APPLICATION NO.	FILING DATE	FIRST NAMED INVENTOR	ATTORNEY DOCKET NO.	CONFIRMATION NO.
09/750,640	12/28/2000	Duane Scott Dewald	TI-30205	6977

Application Number: 09/750,640
Filing Date: December 28, 2000
Appellant(s): DEWALD, DUANE SCOTT

EXAMINER'S ANSWER

APPENDIX
A

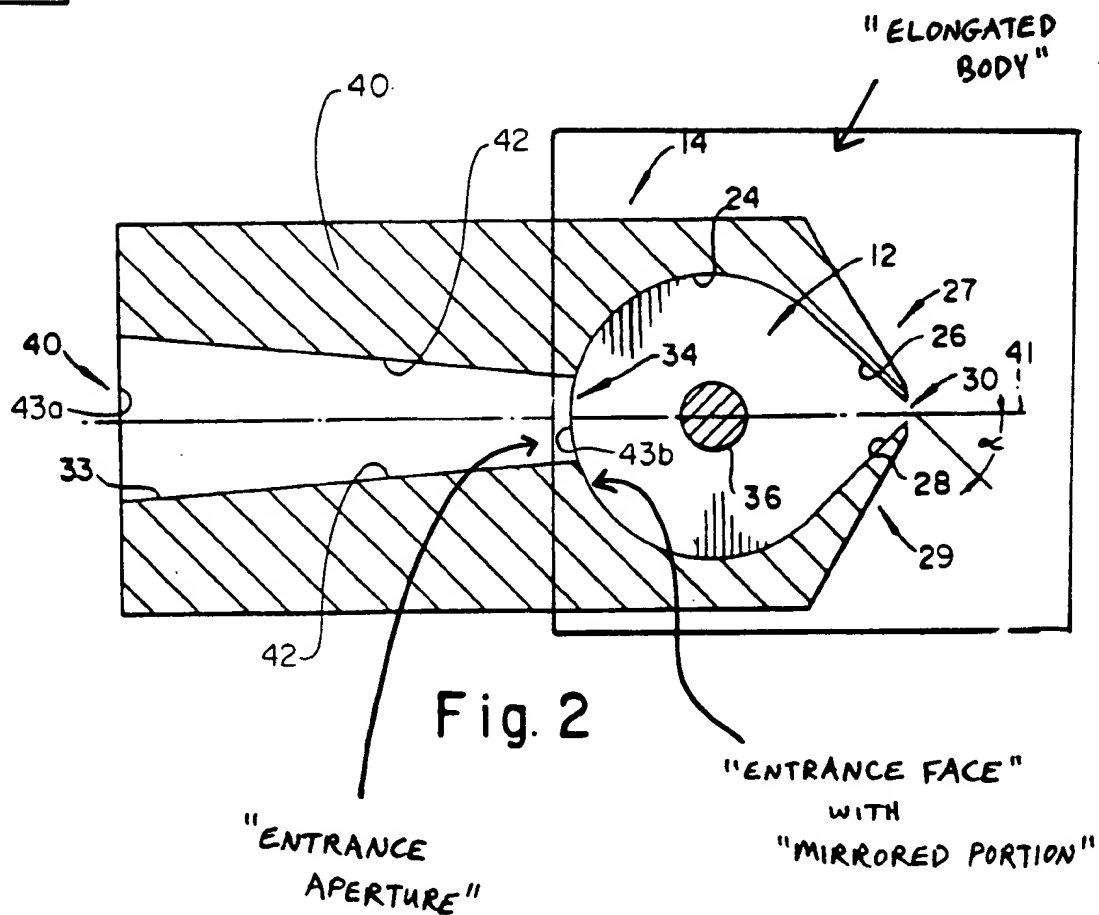
In response, the examiner has provided two annotated copies of Kaplan fig. 2, labeled to show the primary structural features defined in claim 1. Appendix A shows that the structure generally centered around item 12 to be an "elongated body," i.e. an aggregate of matter (this is shown in Appendix A as the structure inside the box labeled "elongated body"). Lacking a specific definition in appellant's specification, the term "elongated" simply requires one dimension to be longer than the other, and this is clearly shown in figure 2. Thus, Kaplan's aperture 34 is located at one end of the aggregate of matter (body) contained within the labeled box.

APPENDIX B

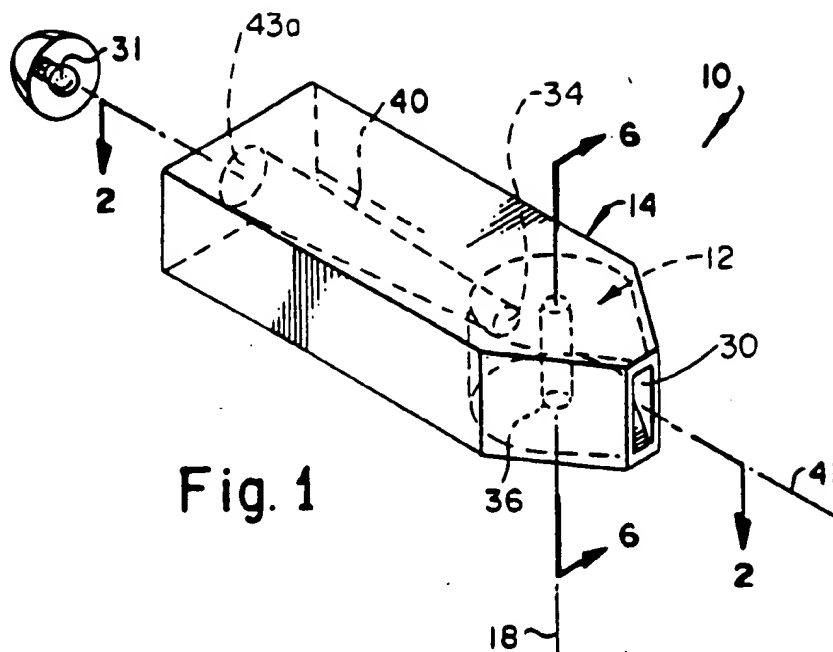
Further, the entire structure generally shown at item 14 in Kaplan fig. 2 may be considered as the "elongated body," and Appendix B includes structural features which are labeled to correspond to this interpretation. Note that the "entrance face" includes a surface at an external end of the "elongated body" (note the surface at the left end of fig. 2). This face includes an "entrance aperture" which allows light to enter the body, with the "entrance face" including a "mirrored portion" on the inside thereof (note that in this interpretation, the "entrance face" is thick and constitutes the area encompassed by the labeled portion shown in Appendix B). This allows light traveling back toward the "entrance face" to be reflected by the

"mirrored portion" in a manner similar to that of the present invention.
